SITE PLAN REVIEW AND APPEARANCE BOARD

CITY OF DELRAY BEACH

---STAFF REPORT---

ITEM: Class V Site Plan, Landscape Plan and Architectural Elevations for Seagate Villas, associated with the demolition of an existing residential structure and construction of a new three-story townhouse building containing three-units.

SITE PLAN
A101

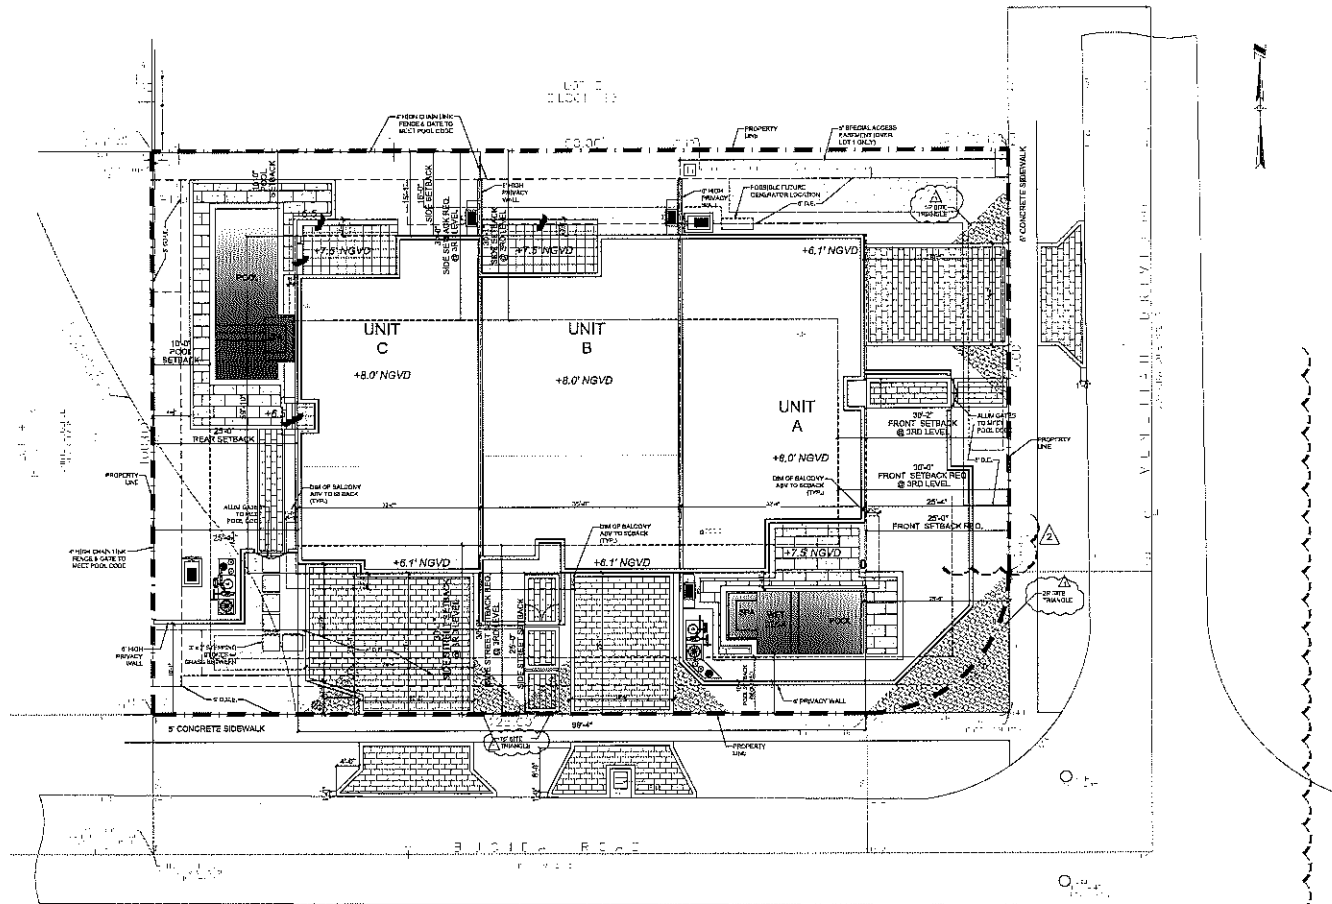
Additionally, pursuant to LDR Section 4.6.14(B)(6), a 40 foot sight visibility triangle is required at the intersection of Venetian Drive and Bucida Road. The proposed six foot high fence located at the southeast corner of the site encroaches within the required 40' sight visibility triangle. A request to reduce the sight visibility triangle was submitted by the applicant and is attached.

The City Engineer has approved the reduction of the sight visibility from the required 40' to 25'

A300

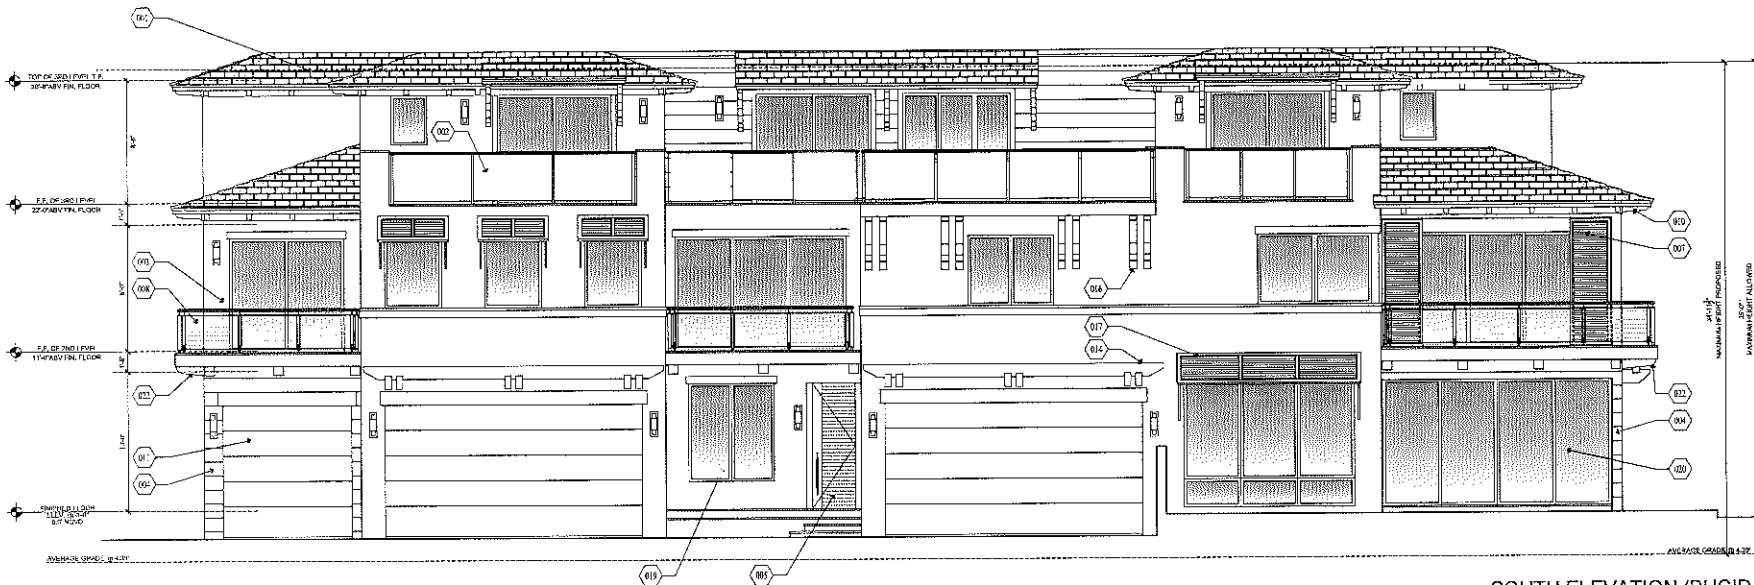
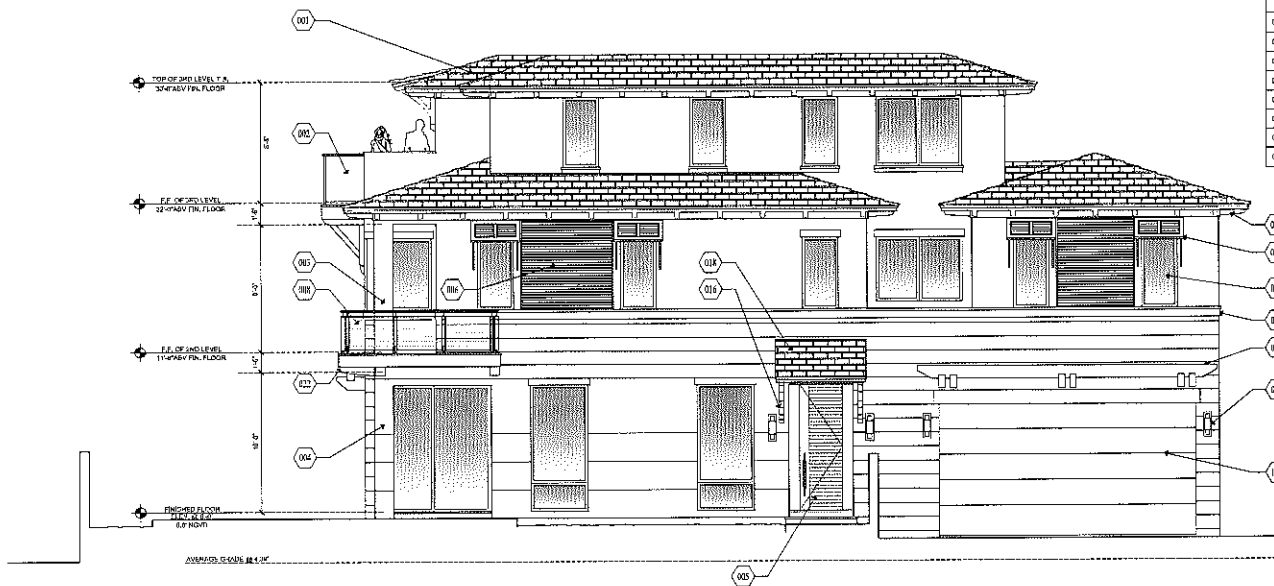
1. That revised architectural elevation plans are submitted to note that the color of the privacy walls matches the Toque white walls of the building prior to the certification of the site plan.
